City of West Sacramento
Flood Engineering Services
Alternatives Analysis Report

Subject: City of West Sacramento – Flood Program Services – Final Alternatives Analysis Report

Enclosed is the Alternatives Analysis Report that was prepared by Wood Rodgers, Inc. for the subject project. Comments from the City of West Sacramento and the Independent Panel of Experts on the draft version of this report (dated March 2016) have been incorporated as appropriate. A comment and response register is included as Attachment D of the enclosed Alternatives Analysis Report.

CUTOFF WALL AT LEVEE CENTERLINE

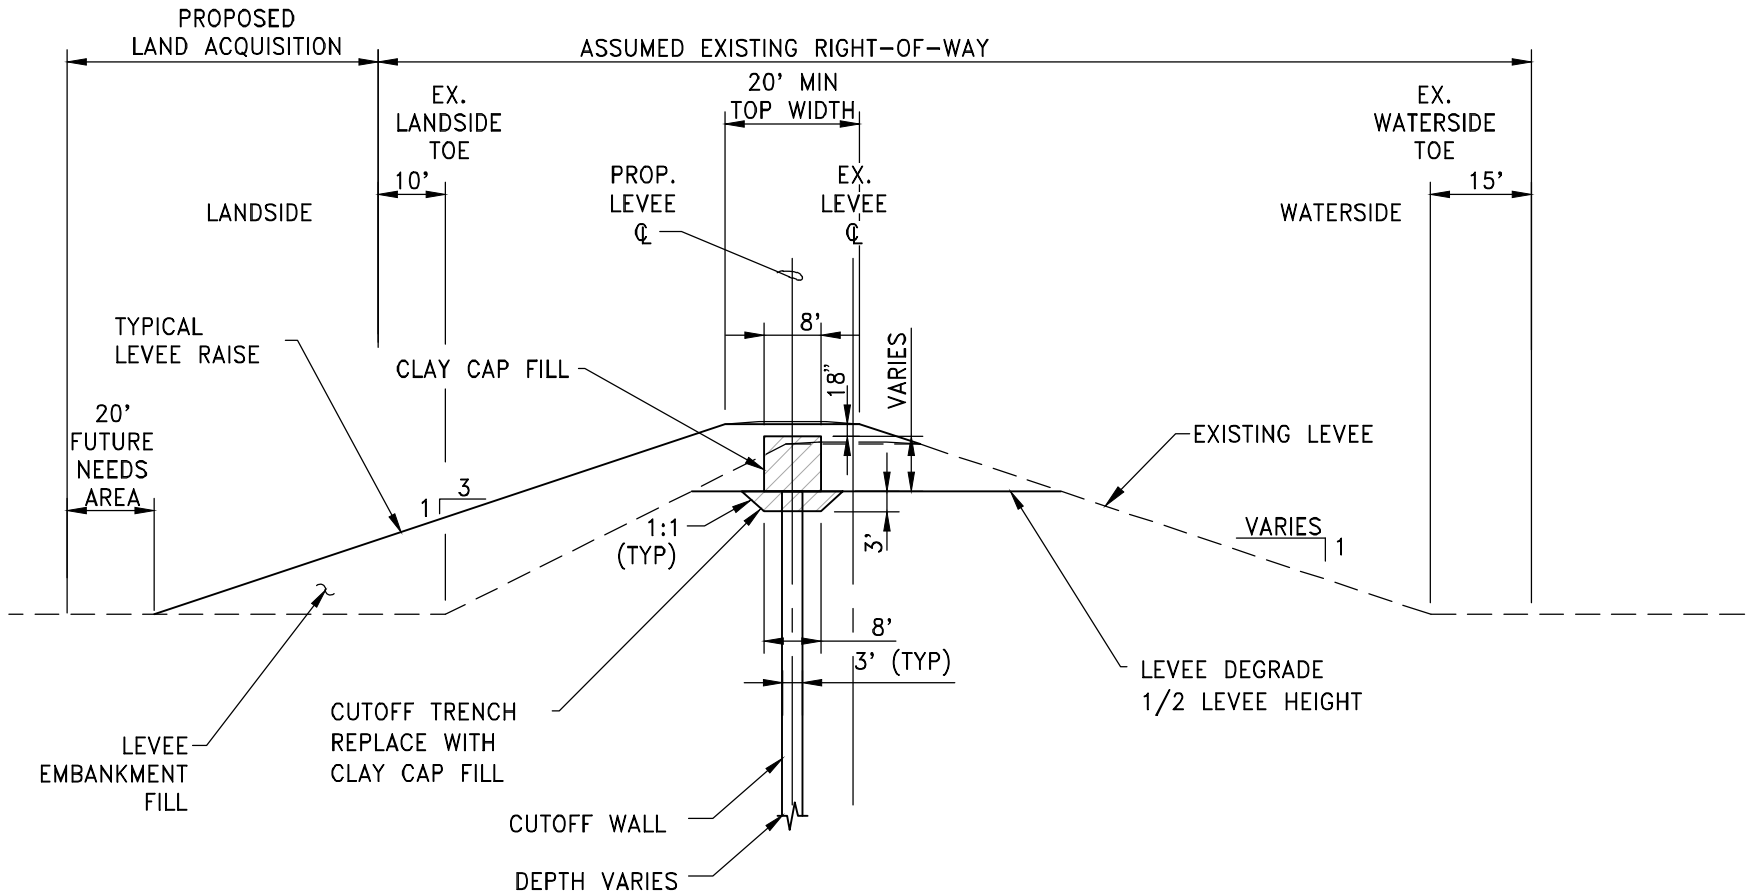
| ADMIN USE ONLY | REVIEWER | | | | RESPONDENT | | | | REVIEWER | | | RESPONDENT | | | |
|---|---------------------------|---|---|--|--------------------------------|-------------------------------------|---|--------|------------|-----|---------------|-----------------|----------------------|---|--|
| 45 | IPE | Figure 3. | 4/17/2016 | Is the 1V:3H landside slope correct? | Jesse Patchett Wood Rodgers | 4/21/16 | Yes. Our typical levee raising includes 3H:1V landside slopes. | X | | | | Y | 5/7/2016 | | n/a |

| ADMIN USE ONLY | REVIEWER | | | | RESPONDENT | | | | REVIEWER | | | RESPONDENT | | | |
|---|---------------------------|---|--|---|--------------------------------|---------------------------------|--|--------|------------|----|---------------|-----------------|------------------|---|---------------------|
| 109 | IPE | Figure 3 | 4/18/16 | Define dashed line on landside slope. Show DWSE schematically. | Jesse Patchett Wood Rodgers | 4/21/16 | The requested information will be included | X | | | | Y | 5/7/2016 | Comment closed pending confirmation in report. | n/a |

FIGURE 4

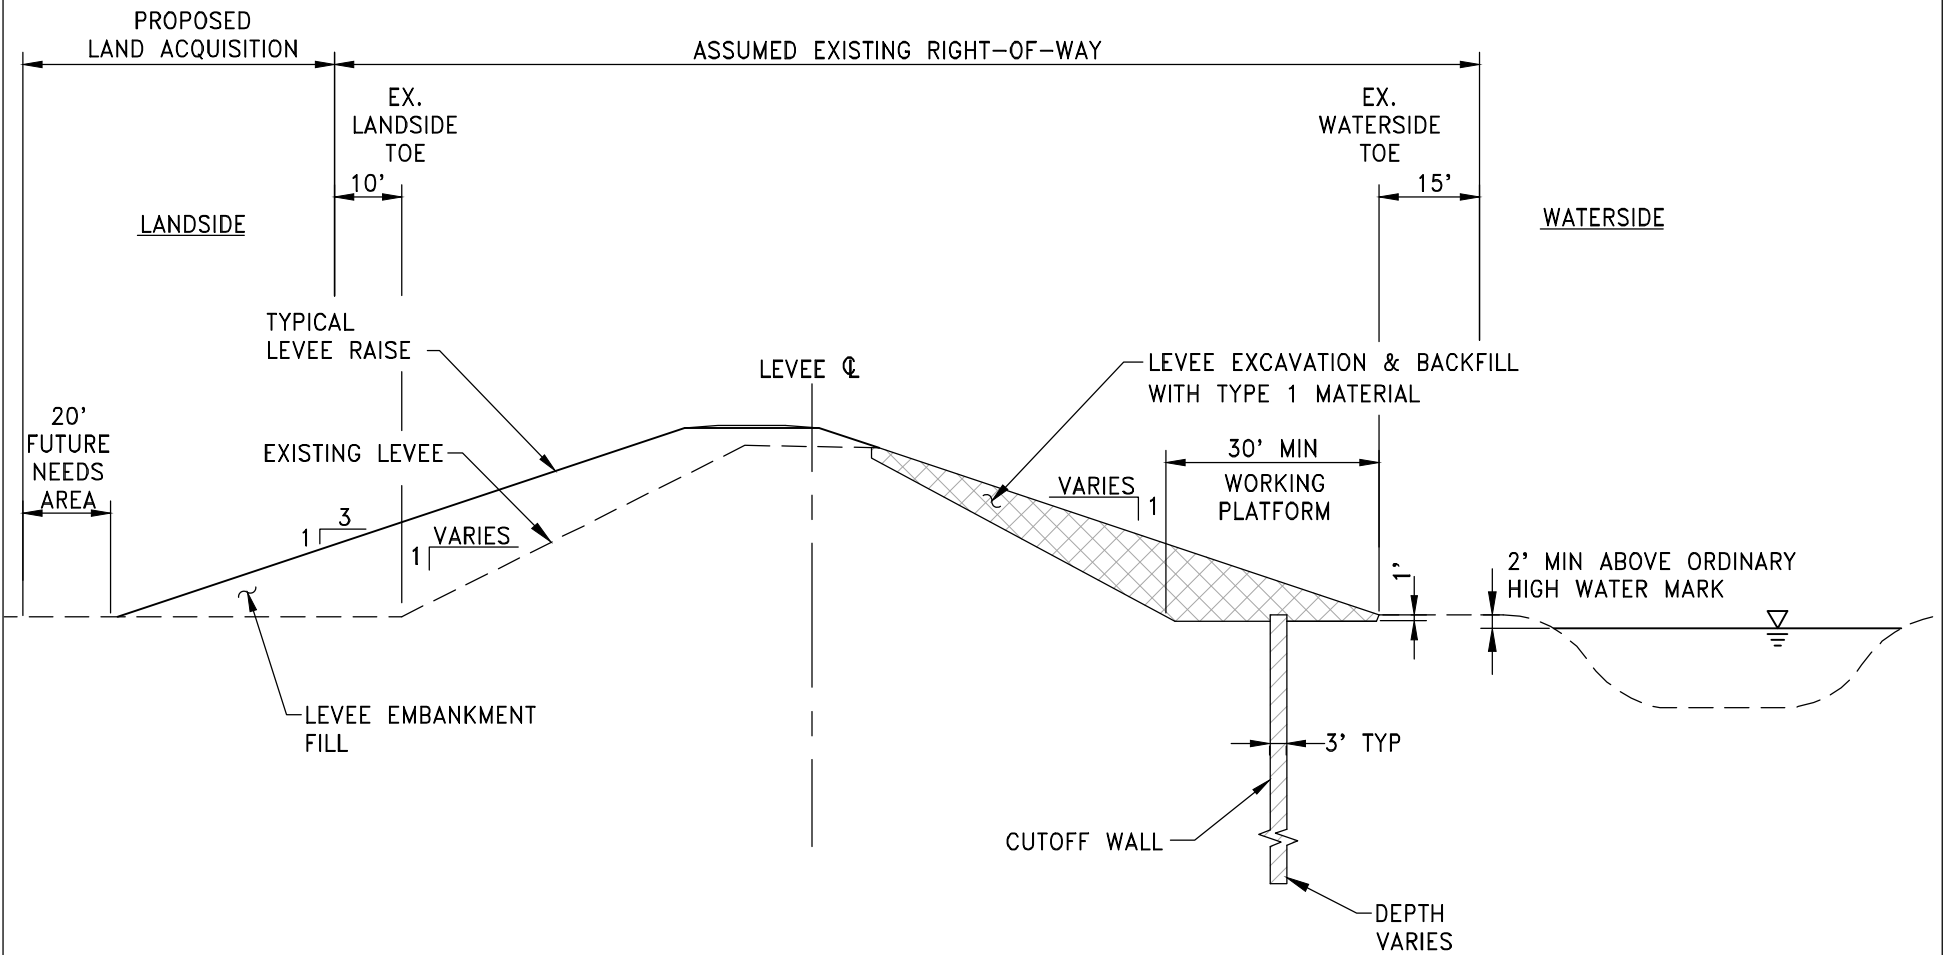
| ADMIN USE ONLY | REVIEWER | | | | RESPONDENT | | | | REVIEWER | | | RESPONDENT | | | |
|---|---------------------------|---|---|--|--------------------------------|-------------------------------------|---|--------|------------|-----|---------------|-----------------|----------------------|---|--|
| 46 | IPE | Figure 4. | 4/17/2016 | Where did the "30 foot" minimum come from? This requires a large excavation into the levee. | Jesse Patchett Wood Rodgers | 4/21/16 | The 30 foot dimension is the required width for an excavator to construct the waterside toe cutoff wall. This measure was not included in any alternative, so the dimensions do not impact the results of the AAR. | | | | X | Y | 5/7/2016 | Comment closed pending confirmation in report. | n/a |

| ADMIN USE ONLY | REVIEWER | | | | RESPONDENT | | | | REVIEWER | | | RESPONDENT | | | |
|---|---------------------------|---|--|---|--------------------------------|---------------------------------|--|--------|------------|----|---------------|-----------------|------------------|---|---------------------|
| 110 | IPE | Figure 4 | 4/18/16 | Define dashed line on landside slope. Was this alternative ever discussed in the text? | Jesse Patchett Wood Rodgers | 4/21/16 | Yes. This was discussed in Section III.A.1: Waterside Versus Levee Centerline Cutoff Wall Installation. This option was ultimately not used as a remediation measure, however. | | | X | | Y | 5/7/2016 | Comment closed pending confirmation in report. | n/a |

DRAINED STABILITY BERM

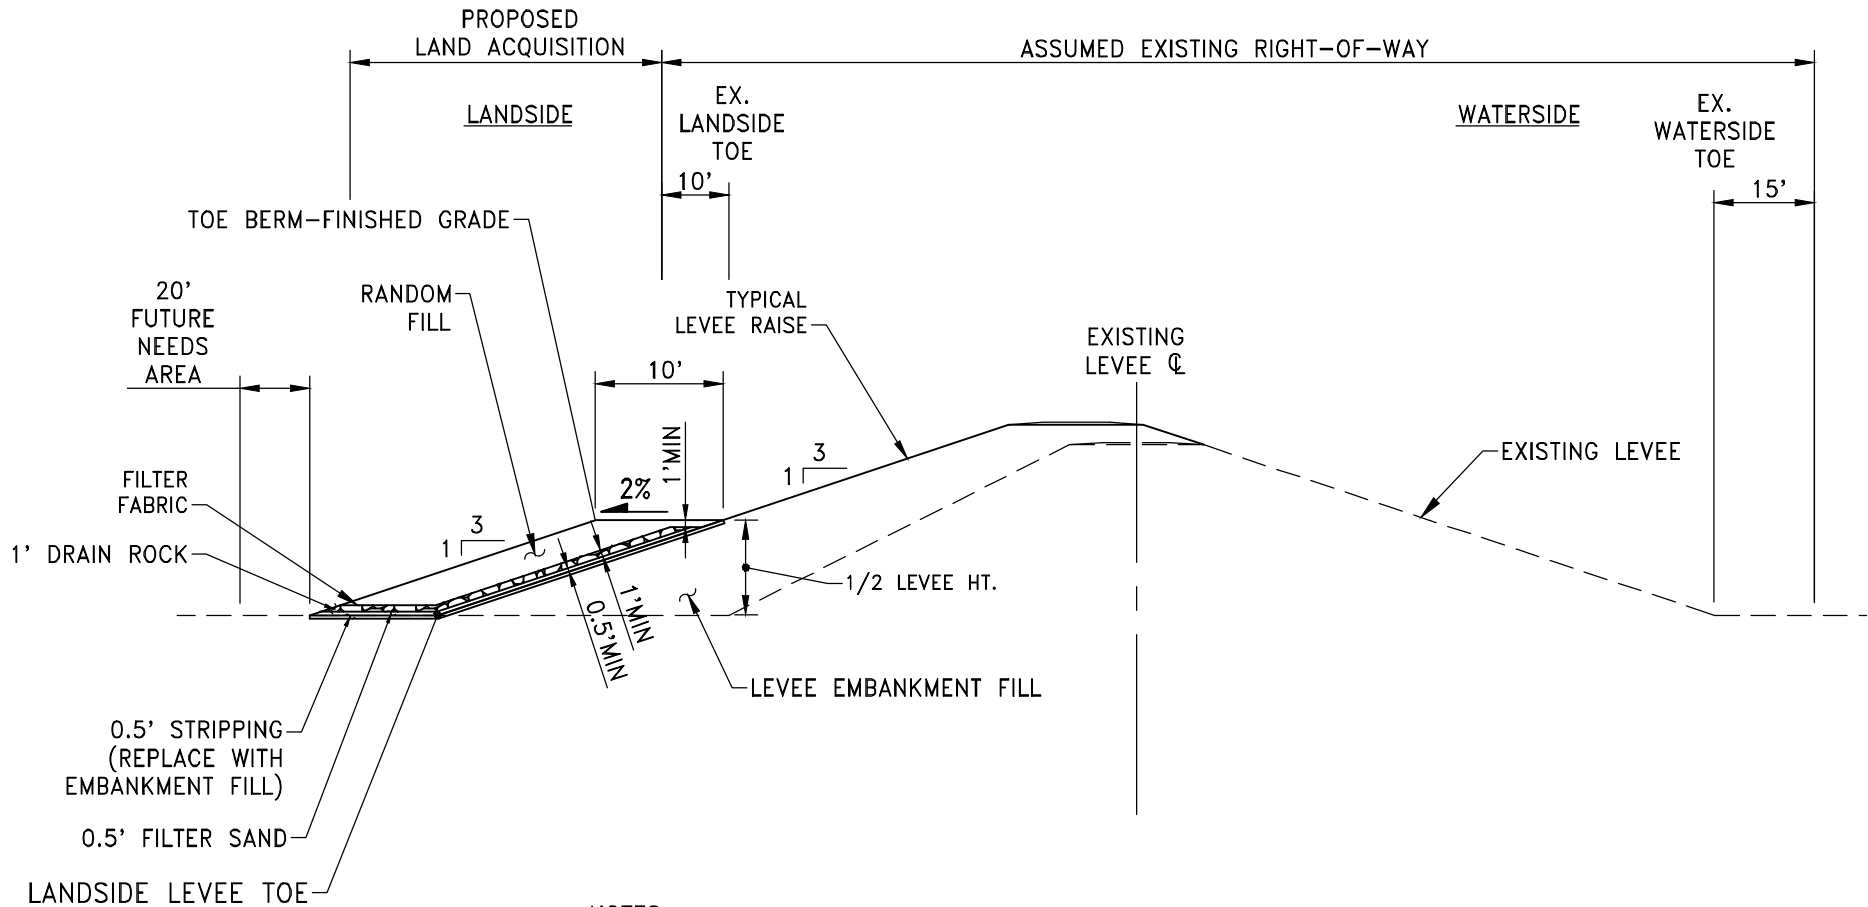
| ADMIN USE ONLY | REVIEWER | | | | RESPONDENT | | | | REVIEWER | | | RESPONDENT | | | |
|---|---------------------------|---|---|--|--------------------------------|-------------------------------------|---|--------|------------|-----|---------------|-----------------|----------------------|---|--|
| 48 | IPE | Figure 6 | 4/17/2016 | If the "Levee Embankment fill" is clay, is this drained berm necessary? | Jesse Patchett Wood Rodgers | 4/21/16 | The levee embankment fill may not be completely comprised of clay. Including a drained berm at this planning stage is appropriate for conservative cost estimating purposes. | | | | X | Y | 5/7/2016 | Comment closed pending confirmation in report. | n/a |

| ADMIN USE ONLY | REVIEWER | | | | RESPONDENT | | | | REVIEWER | | | RESPONDENT | | | |
|---|---------------------------|---|--|---|--------------------------------|---------------------------------|--|--------|------------|----|---------------|-----------------|------------------|---|---------------------|
| 112 | IPE | Figure 6 | 4/18/16 | Should this be defined as a drained stability berm? | Jesse Patchett Wood Rodgers | 4/21/16 | "Drained" has been added to the title of this figure. | X | | | | Y | 5/7/2016 | Comment closed pending confirmation in report. | n/a |

SEEPAGE BERM CUTOFF WALL TRANSITION

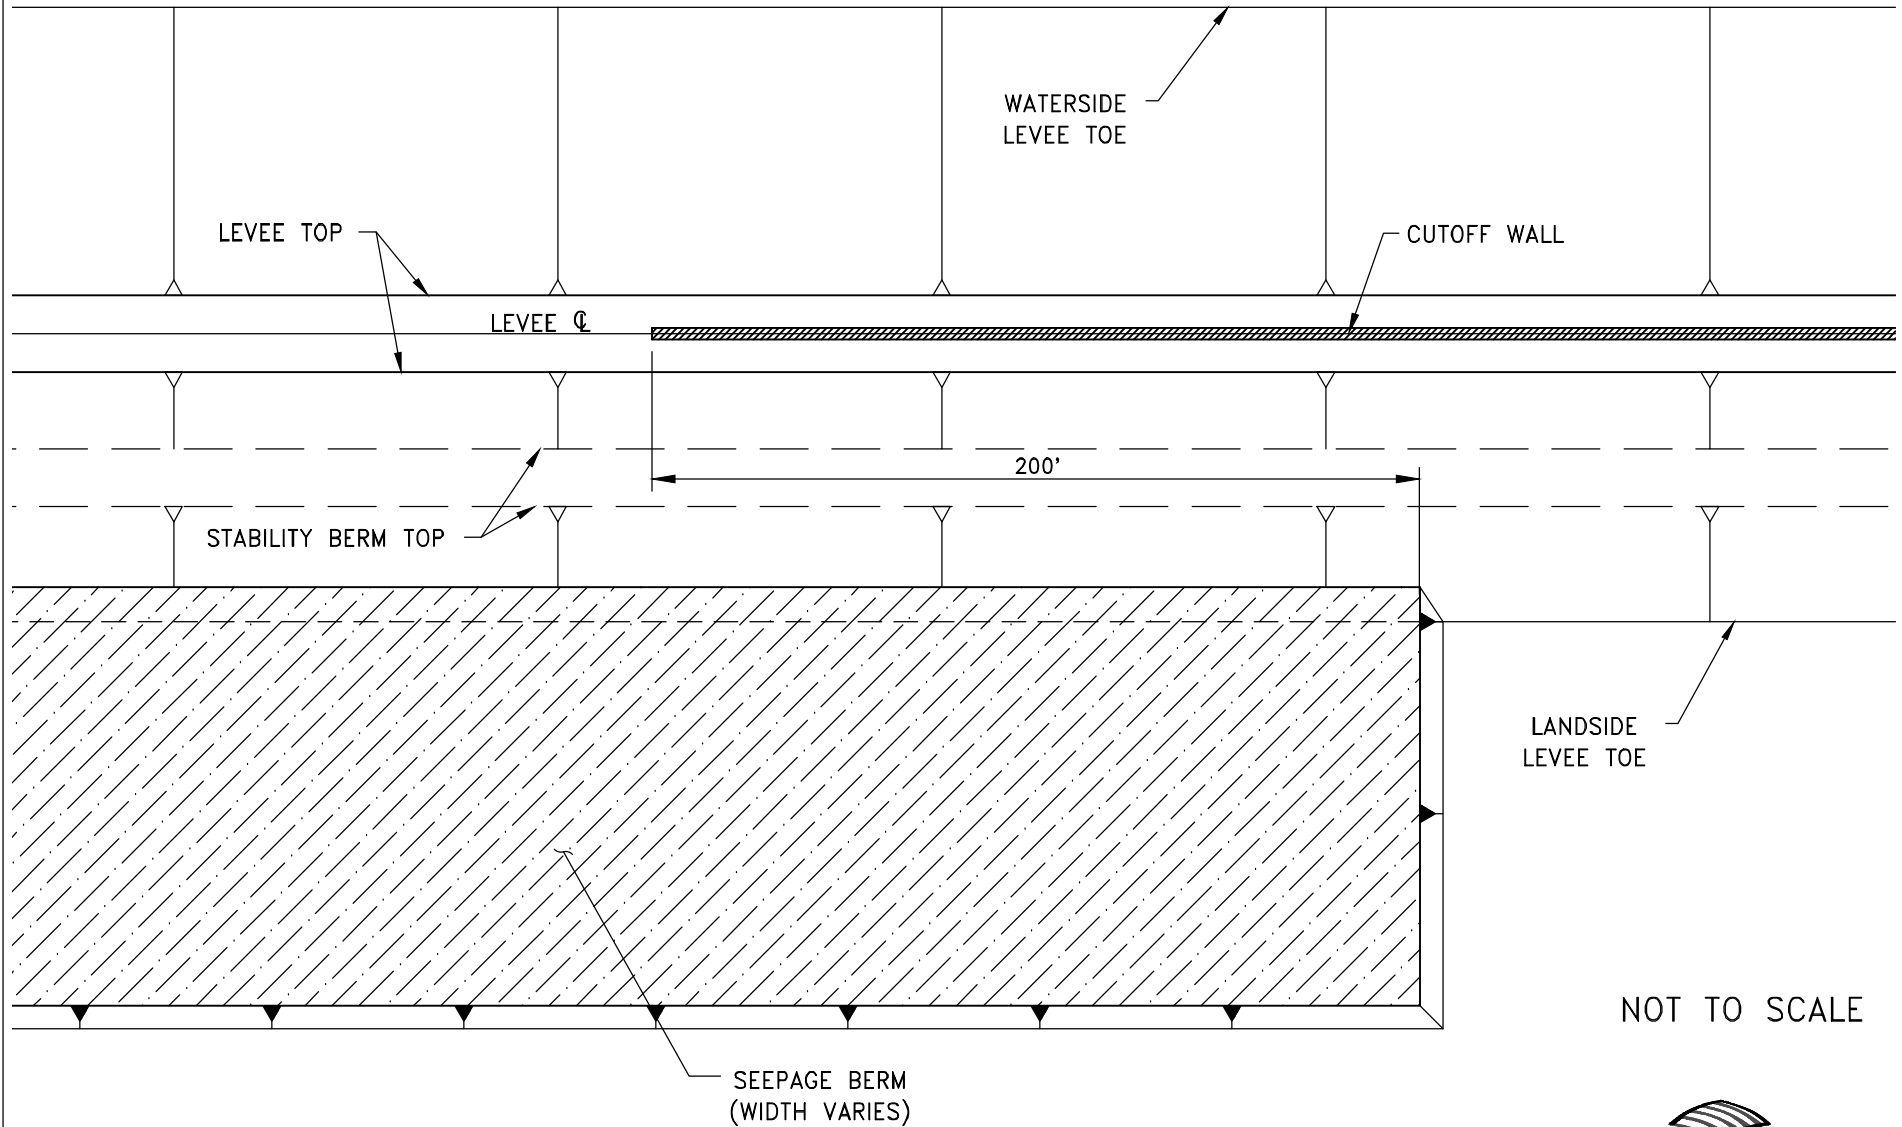
| ADMIN USE ONLY | REVIEWER | | | | RESPONDENT | | | | REVIEWER | | | RESPONDENT | | | |
|---|---------------------------|---|--|---|--------------------------------|---------------------------------|--|--------|------------|----|---------------|-----------------|------------------|---|---------------------|
| 115 | IPE | Figure 12 | 4/18/16 | Should state that the overlap may vary depending upon the conditions - also should state this in the text where appropriate. | Jesse Patchett Wood Rodgers | 4/21/16 | The requested information will be included on the Figure and in Section III.A.5. | X | | | | Y | 5/7/2016 | Comment closed pending confirmation in report. | n/a |

WEST SACRAMENTO FLOOD PROGRAM
 SACRAMENTO RIVER NORTH LEVEE
 REACH 1 - STA 0+00 TO 71+50
 ALTERNATIVE 1 CROSS SECTION

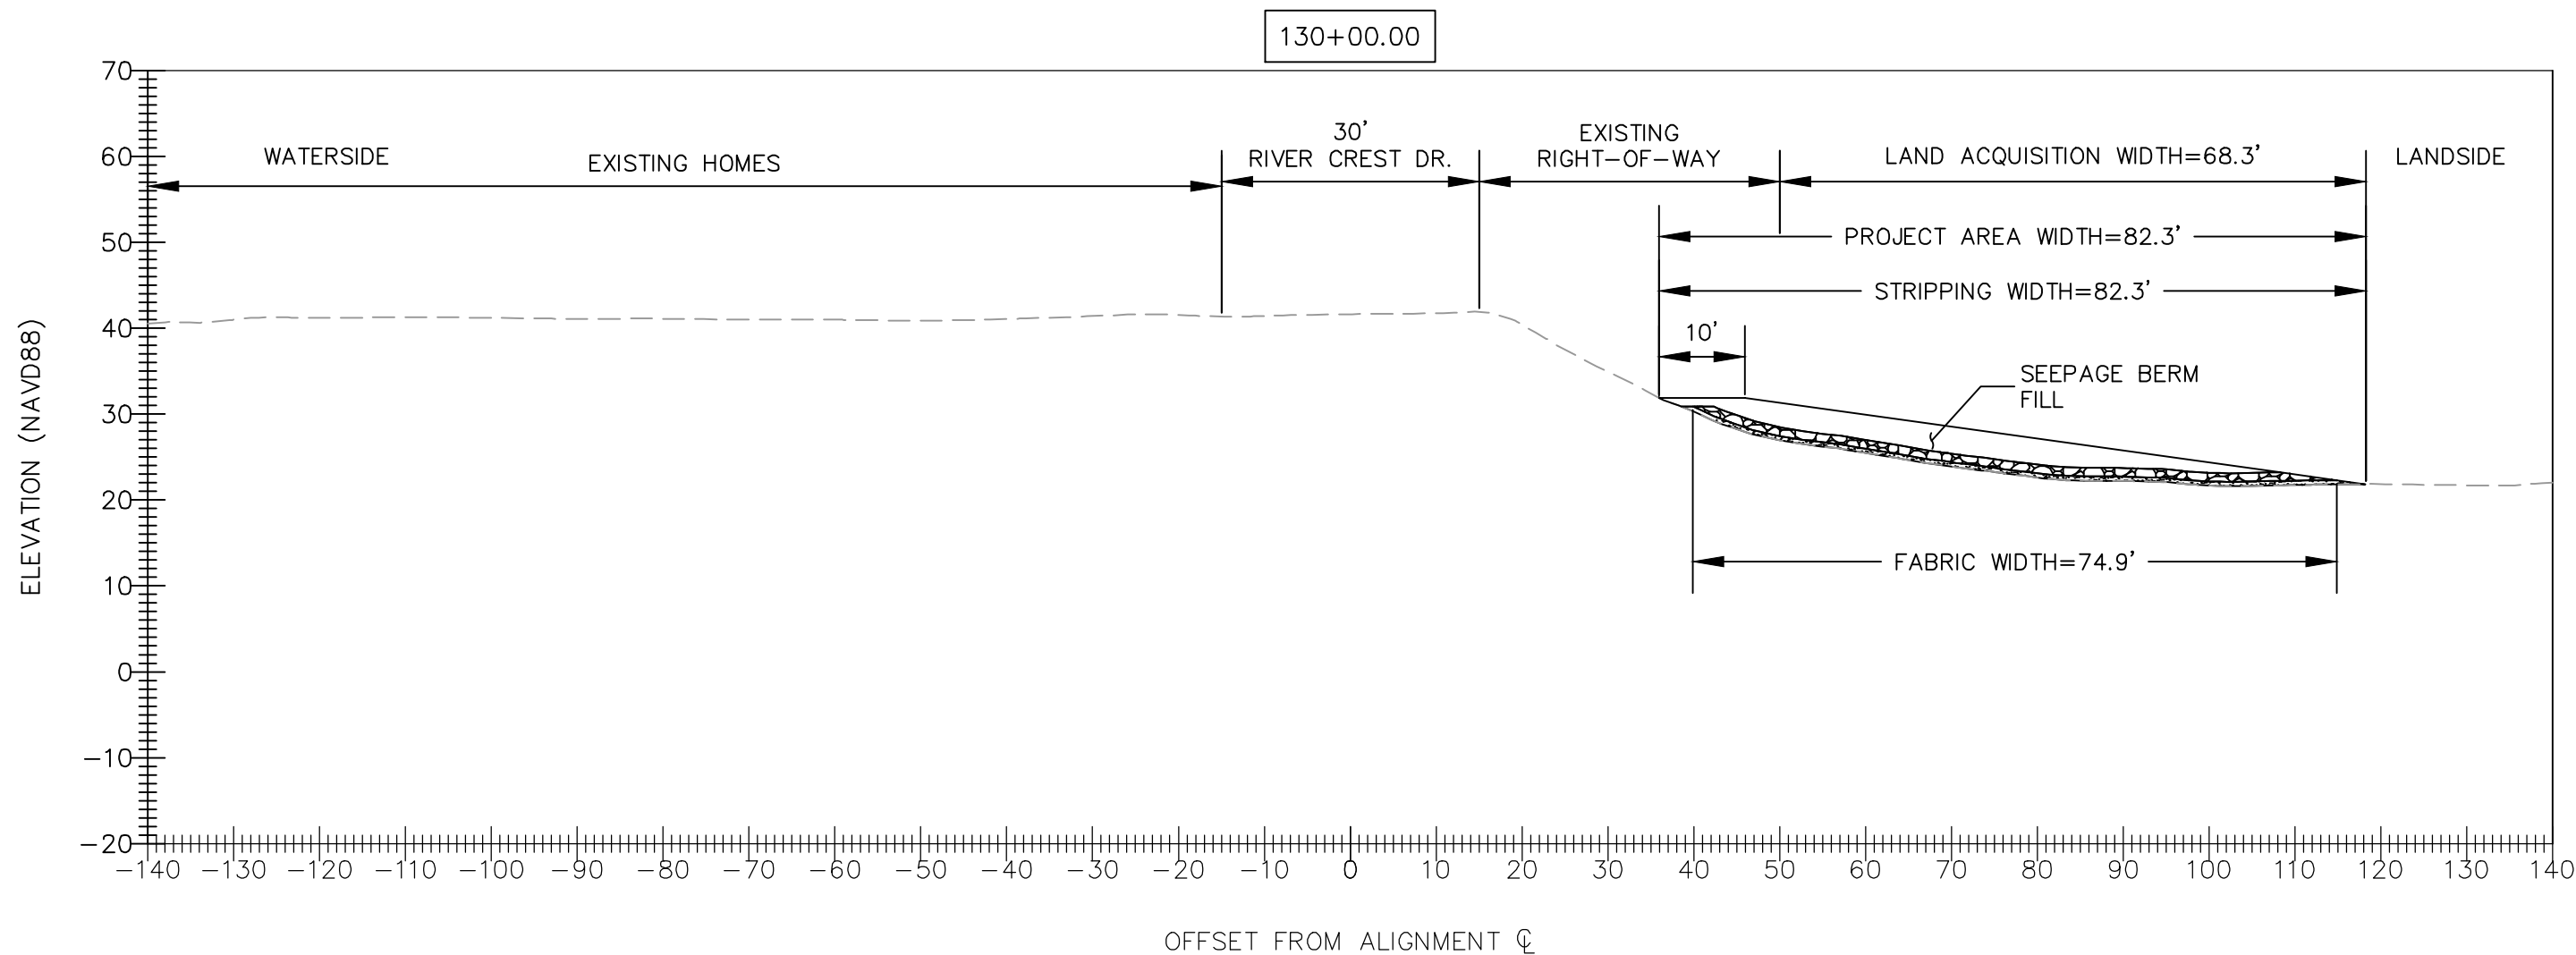
| ADMIN USE ONLY | REVIEWER | | | | RESPONDENT | | | | REVIEWER | | | RESPONDENT | | | |
|---|---------------------------|---|--|---|--------------------------------|---------------------------------|--|--------|------------|----|---------------|-----------------|------------------|---|---------------------|
| 119 | IPE | Appendix B, SRWN Levee, Station 36+00, Figure 1 of 6 | 4/19/16 | Why would you recommend a CB cutoff wall when a SB would be much less costly? This is the only figure that defines the type of cutoff wall. What about a schematic water surface? | Jesse Patchett Wood Rodgers | 4/21/16 | A CB wall is proposed in this Reach due to limited construction footprint vs. an SB wall. This is briefly discussed in VI.A.1. DWSE will not be added to these figures since in some cases, the figures are typical over a mile or more of levee, and the DWSE is not constant over these lengths and this could lead to confusion. Adding this information to each figure will take a significant amount of effort with little value added. Water surface profiles are provided in the PIR. | | | X | | Y | 5/7/2016 | | n/a |
